**Report: Punchlist**  
**Function: Test, Adjust, & Balance**  
**Date: 11/26/2025**  
**Completed By: National TAB**

## 11-24-25 CHIPOTLE #5571 MIDDLEBURG, FL

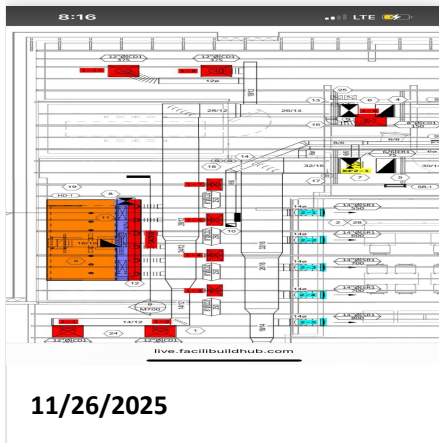
**Issue Name :** Diffuser noise  
**Description :** Diffusers 8 9 and 10 (the office and dishwashing areas) create noise. Possibly due to 4 way deflectors. Not at a level likely to be noticeable or bothersome during store operation. No further action recommended at this time.

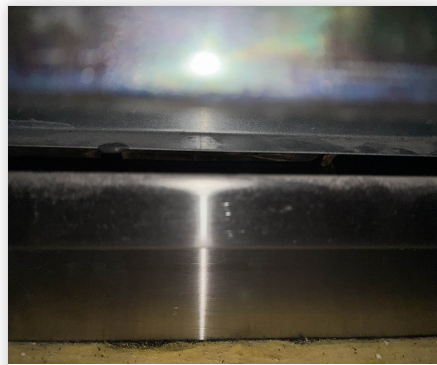
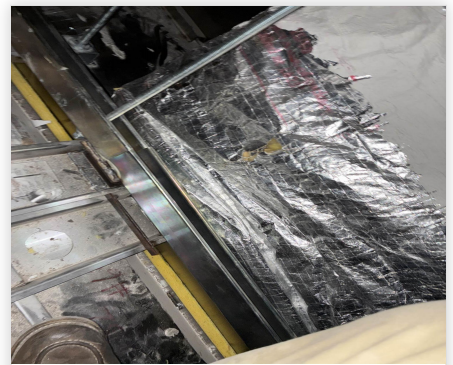
**Issue Name :** MAU leak above hood  
**Description :** There is a moderate air leak where the middle PSP riser joins to the hood.  
**Created By :** National TAB                      **Assigned To :** National TAB - Dan Hertenstein  
**Status :** Open  
**Priority :** **Urgent**                                      **Asset Tag :**  
**Originated Date :** 11/26/2025 - Jackson Gunnels - National TAB
